Addendum No. 1

To:	All Plan Holders	**Project:**	Airfield Electrical Improvements
Airport:	Spearman Municipal Airport	**KSA Project No.:**	100970
Date:	Tuesday, November 3, 2026	**TxDot CSJ No.:**	2504SPEAR

The plans, specifications, and contract documents are modified as described below. All bidders shall acknowledge receipt of this and all other addenda on the bid form. This addendum becomes a part of the contract documents. All provisions of the original plans, specifications, and contract documents shall remain in full force and effect, except as modified by this addendum.

ELECTRICAL
DEMOLITION SITE PLAN II

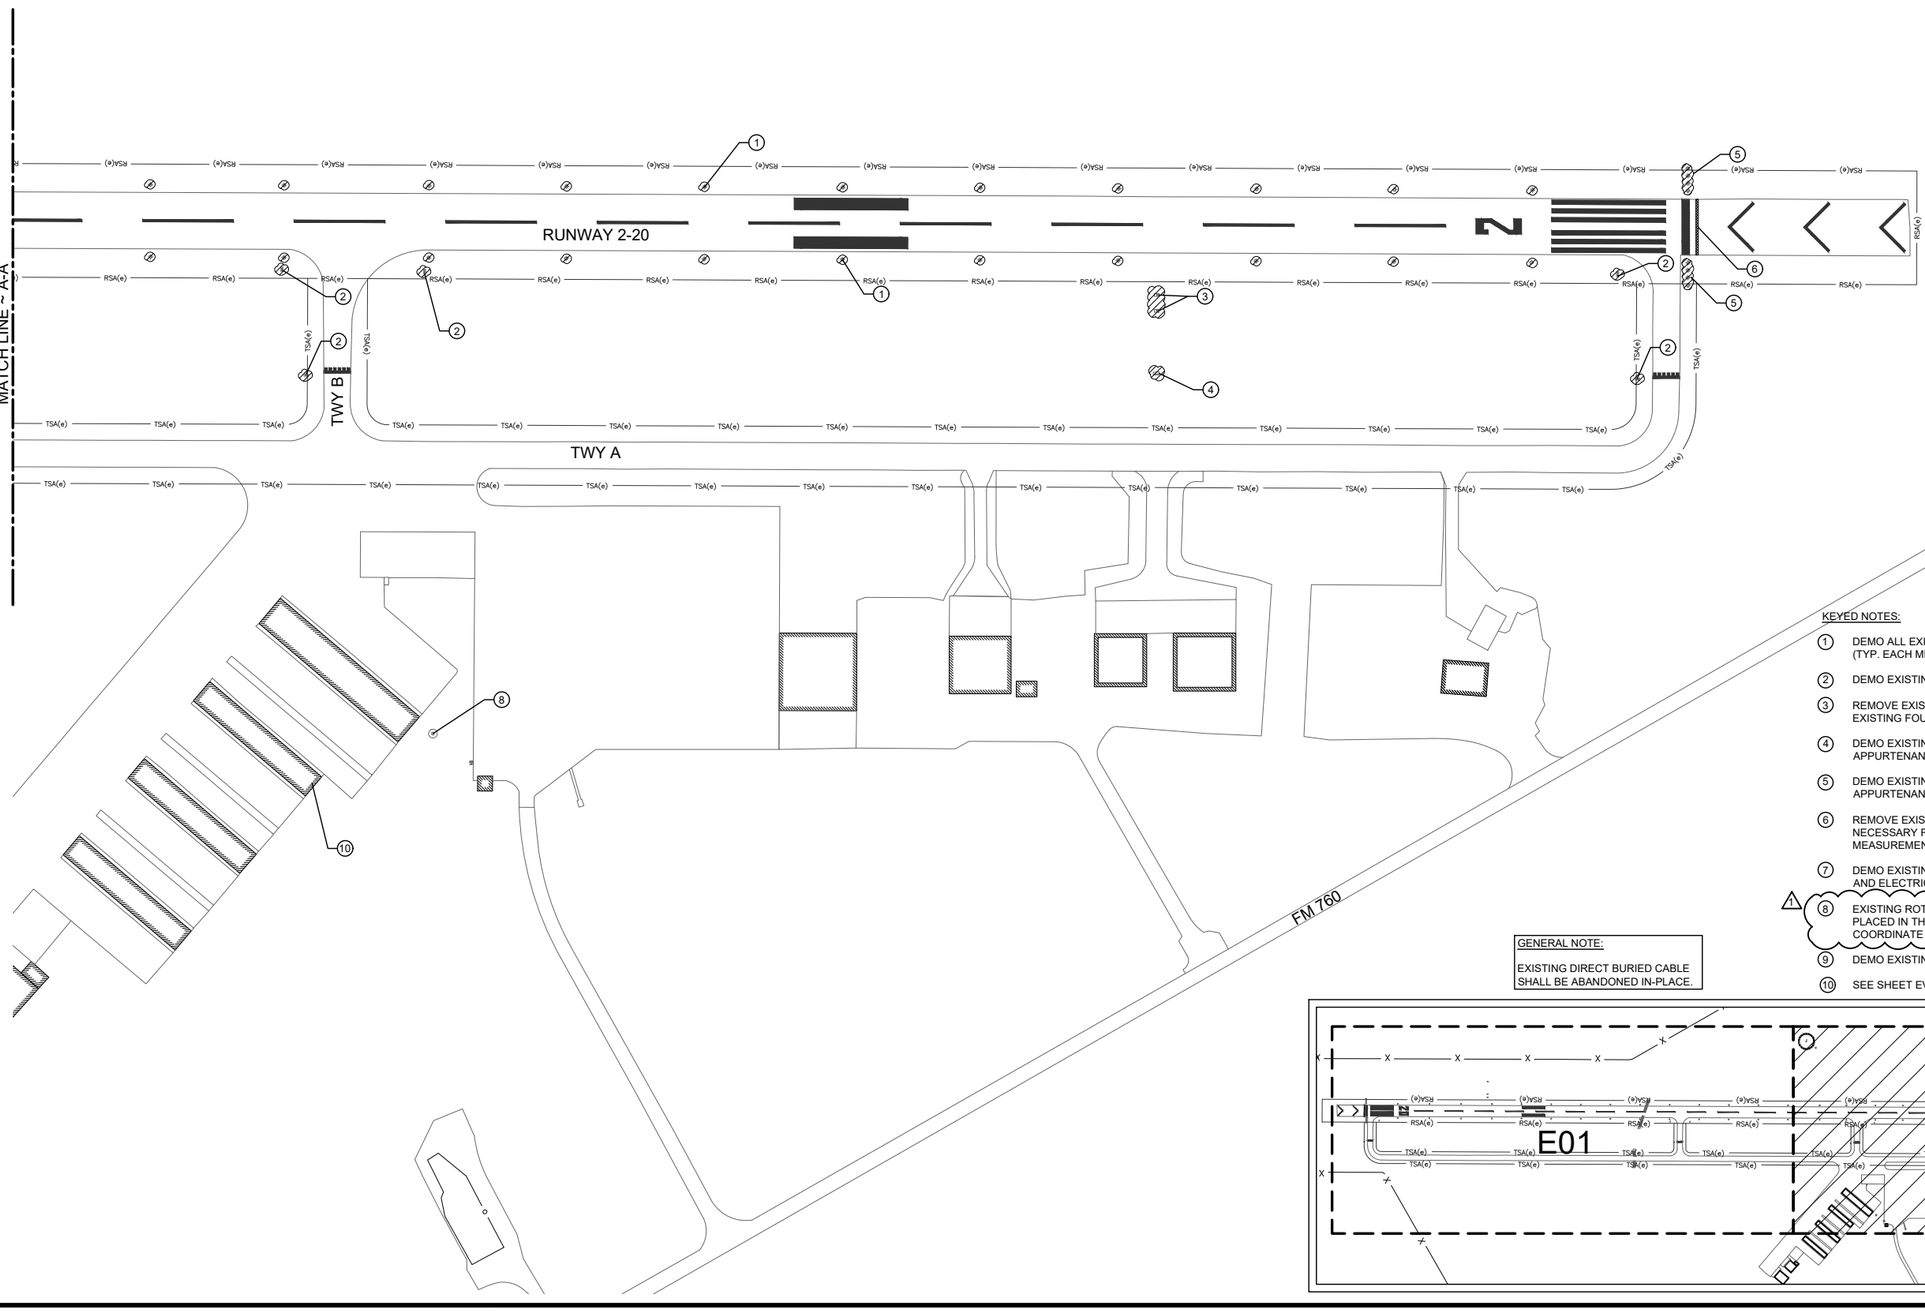
8. EXISTING ROTATING BEACON AND TOWER SHALL BE REMOVED AND PLACED IN THE FIELD WEST OF THE T-HANGARS. CONTRACTOR SHALL COORDINATE WITH THE RPR ON EXACT LOCATION OF PLACEMENT.

3 **LED PAPI L-881 INSTALLATION DETAIL**

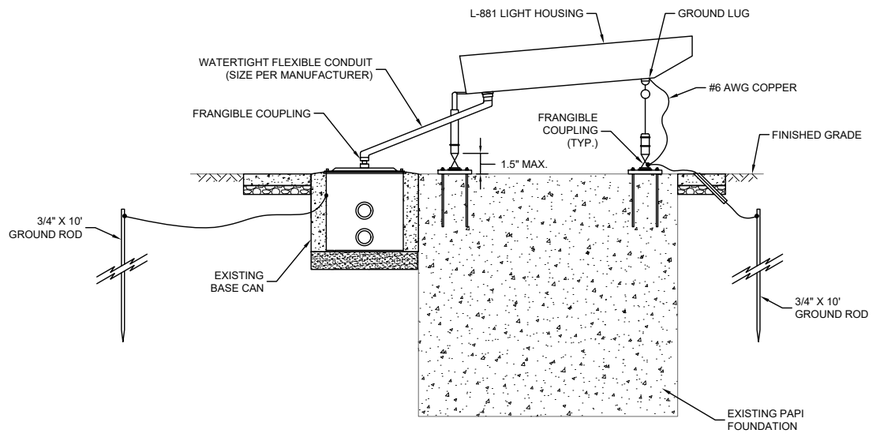
B. Should the PAPI's be Style A or B (detail in plans calls for B, L-125 2.10 calls for A)?
   1. PAPIs are Style A.

DETAIL REMOVED
PER ADDENDUM #1

3 / EV-2 **PROPOSED ONE-LINE DIAGRAM**

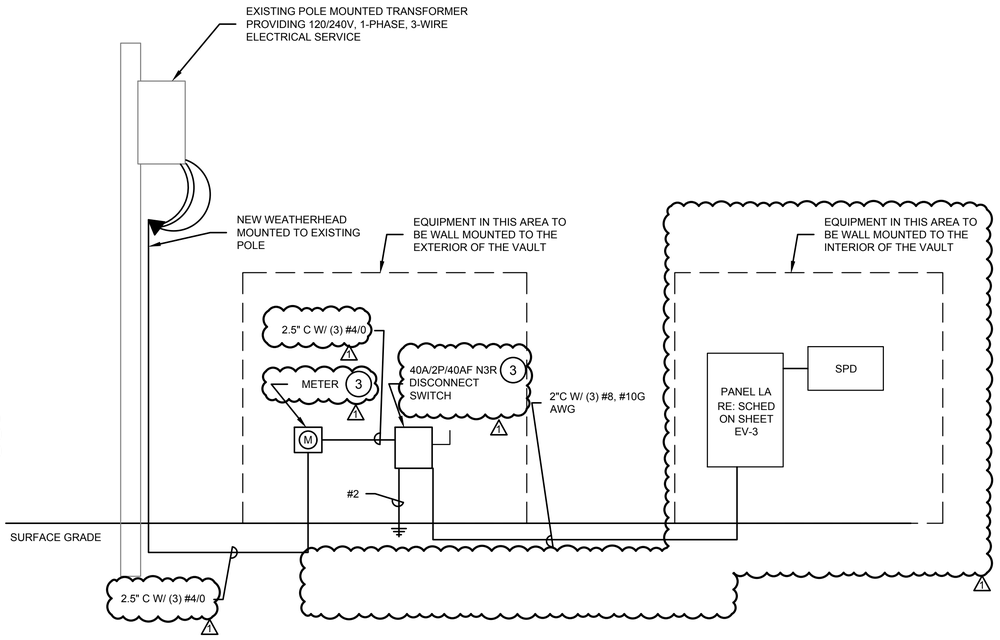
E. Detail 3/EV-2 does not match detail 2/EV-3, clarify if equipment TVSS is needed.
   1. Panel "LA" will require an SPD.

1. INSTALL NEW 4 KW, 240V, 3-STEP, FERRORESONANT TYPE L-829 REGULATOR. INSTALL ASSOCIATED 5KV CABLES, 600V CABLES, CONTROL CABLES, AND PATHWAYS FOR CONNECTIVITY.
2. INSTALL LOAD CENTER WITH TYPE 1 SURGE PROTECTION DEVICE.
